# Review of August 2007, Urbandale LRT Network Plan

by McCormick Rankin Corporation

October 2007

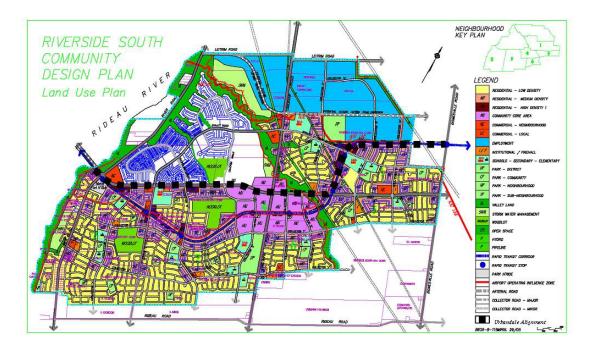
CDP (including the transit corridor) is shown below with Urbandale's proposed Armstrong Road alignment superimposed on it.

The significant differences between the two corridor options are highlighted below:

Earl Armstrong Road alignment (Urbandale proposal):

- Located on a major arterial with high volumes of traffic and limited right-ofway;
- Potential conflicts between LRT operations and traffic turning movements;
- Potential interference to LRT operations from emergency operations at the newly-built fire hall on Armstrong Road;
- Least opportunities for future transit-oriented development (low-density residential development already exists on the north-side of the road);
- Not readily accessible for a majority of transit users in the community (need to bus or walk to stations on Armstrong Road);
- Would require a redesign of the Riverside South CDP to relocate some of the higher density development to within walking distance of Armstrong Road transit stations.

CDP/North-South LRT EA Alignment:

- Located in the centre of the community, with highest density development adjacent to the transit corridor;
- Stronger positive influence on future transit oriented development on both sides of the transit corridor;
- Attracts higher ridership because of proximity to a higher proportion of walk-in traffic from future development.

The corridor selected as part of the community design process and reconfirmed as part of the North South LRT EA is considered to be more transit supportive than the Armstrong Road corridor in that it has the potential to attract more ridership and that it can provide better service to the planned high and medium density residential development south of Armstrong Road.
